MODEL HD CARBURETOR ACCELERATING PUMP CHECK VALVE

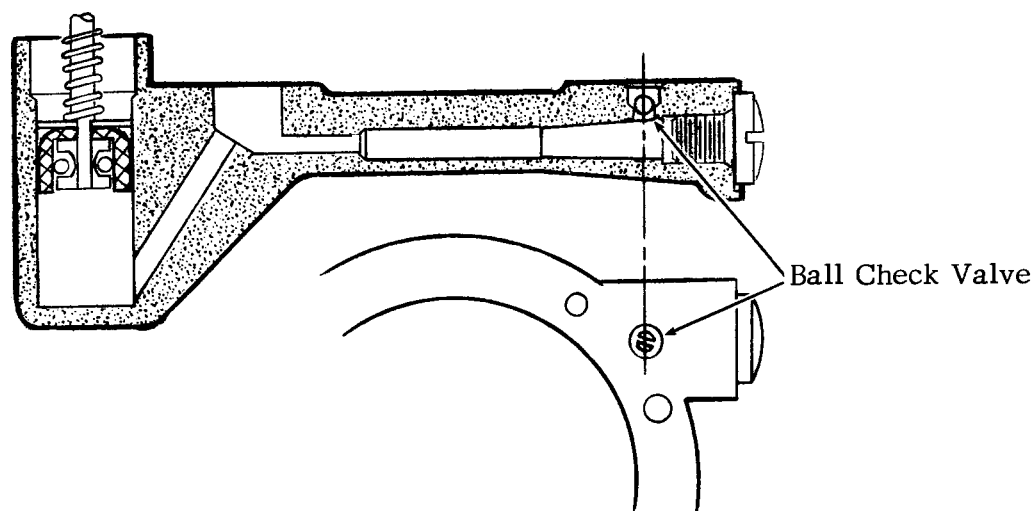
Late 1968 Sportster and Electra Glide Model Carburetors were recently changed to incorporate a ball check valve in the accelerating pump passage of the plastic cover. The illustration below shows the pump discharge passage and check valve, which provides a positive seal against air bleeding back from venturi into fuel chamber.

Electra Glide carburetor, part No. 27160-66B, incorporating the new ball check valve, is stamped HD-2D or HD-2CD on the intake manifold flange.

Sportster carburetor, part No. 27162-66B, incorporating the new ball check valve, is stamped HD-1BC or HD-1C.

Pump body, part No. 27804-66A, now supplied for parts orders, has the new ball check valve and replaces part No. 27804-66, which did not have ball check valve.
